<b>Date Issued :</b>	April 12, 2022	<b>PCN Number :</b>	511912
<b>Reason for Change :</b>	Change to Product		
<b>Description of Change :</b>	Servo cables 155311/21/31 update  The change impacts the internal wire pair color, changed from black & black to black & white and diameter of insulation for AWG16 pair, position of Yellow/Green core and external diameter. The change has no impact on fit, form and function of the product. Just the aesthetic will be affected. The reason of this change is to align the cable to the most commonly used coloration in the market for such cables.		
<b>Reason for Short Notice :</b>	Special Request		
<b>Assessment of Change :</b>	First Article Inspection		
<b>Planned Implementation Date :</b>	April 20, 2022		
<b>Sample Availability Date:</b>	April 08, 2022		
<b>Internal Molex Qualification Date :</b>	April 08, 2022		
<b>Last date to request Samples by Customer :</b>	April 13, 2022

- SERVO CABLES 155311/21/31 – WIRE PAIR COLOR CHANGE**

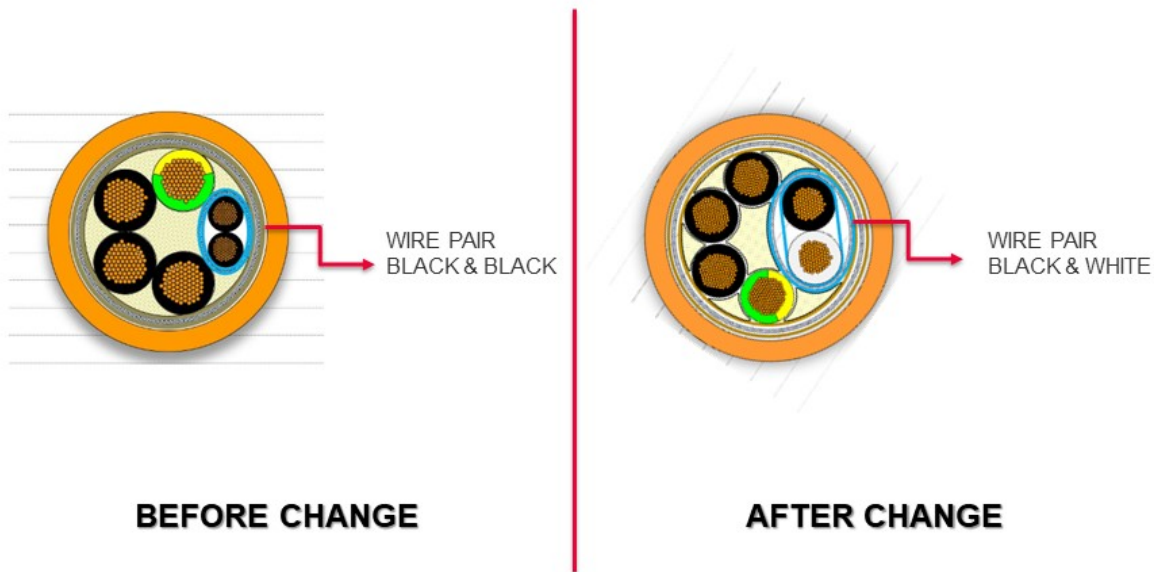
- This document is to inform you that Flamar is updating the internal pair wire color of servo cables 6 circuits, series 155311, 155321, 155331 – from black & black to black & white.
- The purpose of this change is to align to the most commonly coloration used in the market for such cables, increase the 16AWG pair diameter and to increase the total diameter in higher tolerance, the position of yellow/green core.
- The change will NOT impact fit, form and function of the product.
- The pictures on the left represents the change.
- *See attached the impacted parts list.*
